Karnaphuli Sportswear Industries Ltd. (Extension)

23 January 2025

1. Building InformationExecutive Summary

2. Observation

Observation-1: Discrepancies in as built drawings (KSL-3 new part)

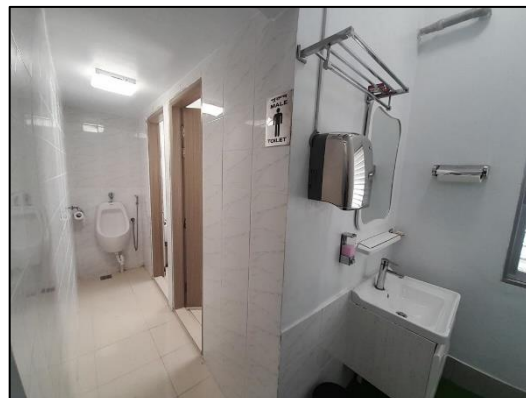
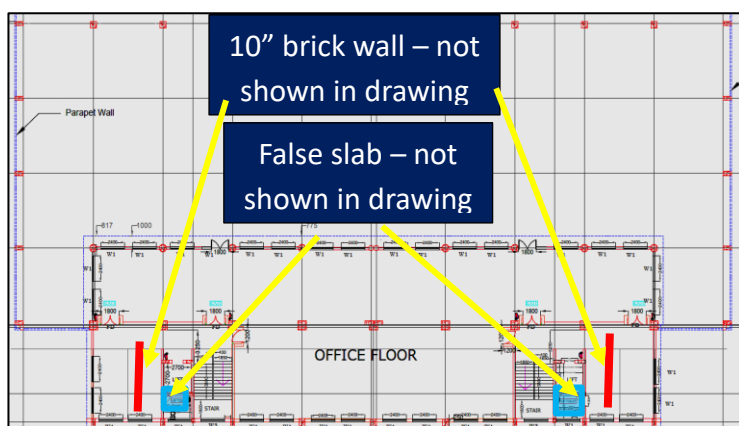
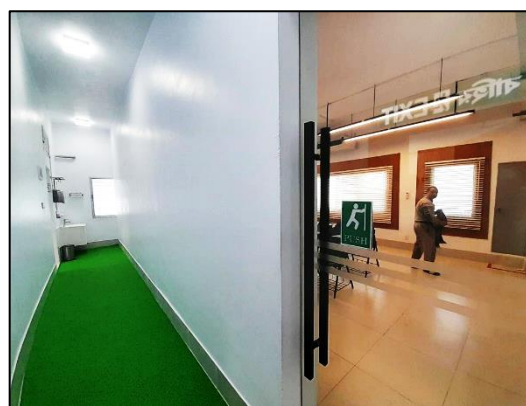
1st to 4th floor plan

False slab at toilet area

5th floor layout plan

10" brick partition wall

Description: Some mismatches (false slab at toilet area, partition wall layout etc.) were found between onsite condition and as-built drawing. The building engineer is required to survey the full structure, update as-built drawings as per site condition and incorporate in the assessment.

Observation-4: Discrepancies in as built drawings (KSL-3 Old part).

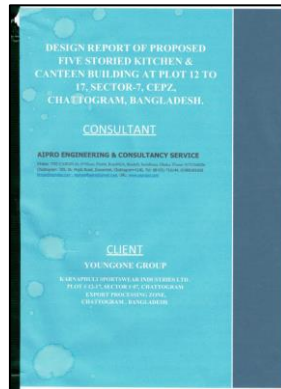
Undocumented plastic water tank at roof.

C4 column found 400x400 instead of 500x500 on the ground floor.

Description: Some mismatches (column C4 size at ground floor, undocumented plastic water tank on roof) were found between onsite condition and as-built drawing. The building engineer is required to survey the full structure, update as-built drawings as per site condition and incorporate in the assessment.

Observation-6: Inconsistency and lack of information in the Design Report (Kitchen & Canteen Building).

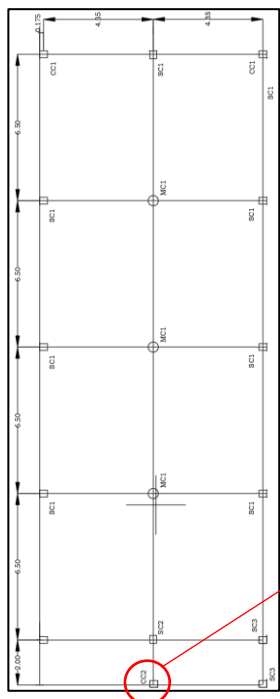
Description: Detailed seismic calculation and framing system consideration not provided in the design report. Concrete strength considering BNBC 5.12.1 not incorporated. Also, serviceability checks not incorporated in the design report.

Building engineer is required to revise the design report as per BNBC 1.9

Observation-15: Inadequate member size and stability (RO Plant 3, Pump House)

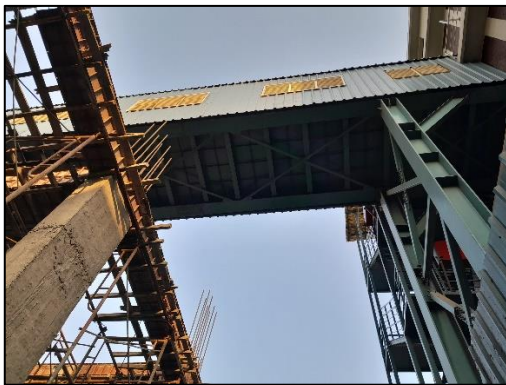
RO Plant

Pump House

Description: Inadequate member size and stability system were observed. The building engineer is required to check the member adequacy and prepare a safety check report.
